From: [David Catanach](#)
To: [Goetze, Phillip, EMNRD](#)
Cc: [Murphy, Kathleen A, EMNRD](#); [Powell, Brandon, EMNRD](#); [Joe Tarver](#)
Subject: RE: [EXTERNAL] RE: Tarco PMX-305 Brad State #6
Date: Wednesday, November 3, 2021 6:45:09 AM
Attachments: [image001.png](#)

I am reviewing the PMX-305 for the Brad State #6. It is still under the River Unit #5 well name in the well file. Did Tarco put in a C-103 for a request for a name change and get it approved? I did not see it in Imaging. If not, I will have to write the order using the Riverwolf well name. thanks

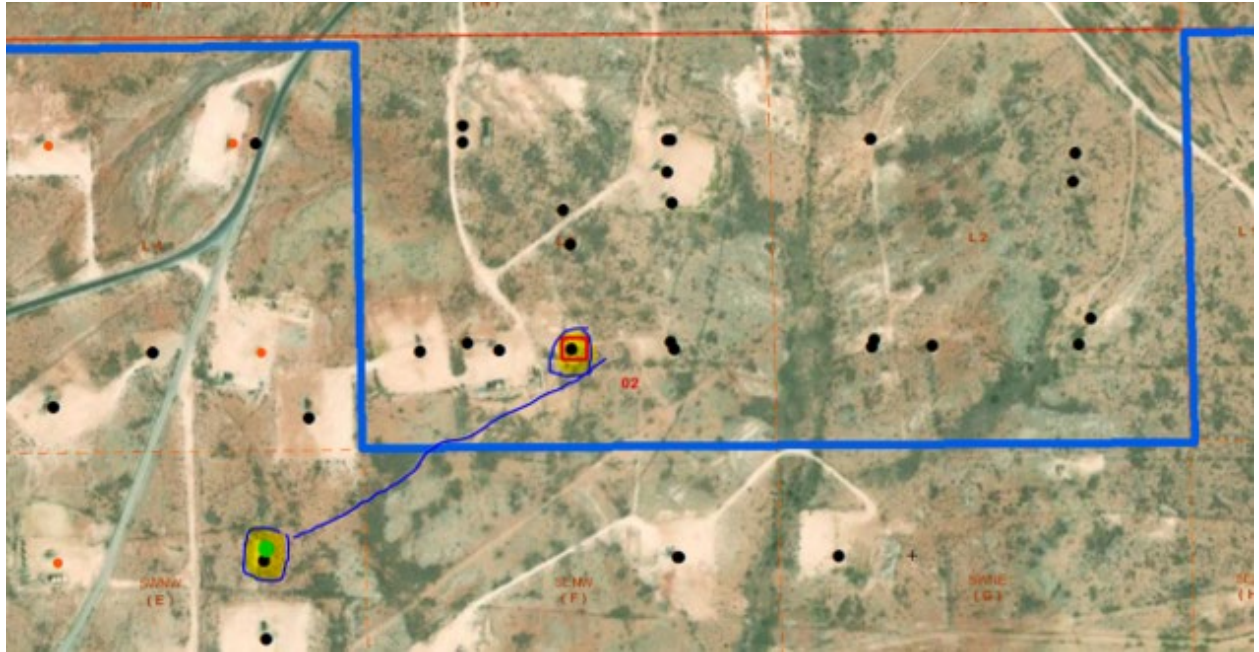
After discussions with Mr. Goetze, I will need more information on the status of water well that is 0.2 mile to the SW of the Riverwolf Unit 5 well, as mentioned below. It appears this water well was not identified in the original application. I agree that the other well to the SW is not in the AOR, as it is just over 1.2 miles in distance.

Also, please elaborate on the fresh water well sampling. Were there samples obtained in a previous order? There is a FW well to the southwest of the river wolf unit (0.2 mi) although I don't know whether it is a viable well at this point. But this section needs more specifics.

Tarco had its field personnel conduct a search of the area in the vicinity of the fresh water well identified as being 0.2 miles southwest of the Riverwolf Unit No. 5. The attached photo shows the results of that area search. The well in question appears to have been plugged and abandoned at some point in the past.

Mr. Joe Tarver, the President of Tarco Energy, LC recalls that there was a residence/farm house on or near that fresh water well site in the distant past. The house has long since disappeared, and there are not any other structures nearby. We can only ascertain that this well certainly was abandoned and it is highly unlikely that it will be used again.
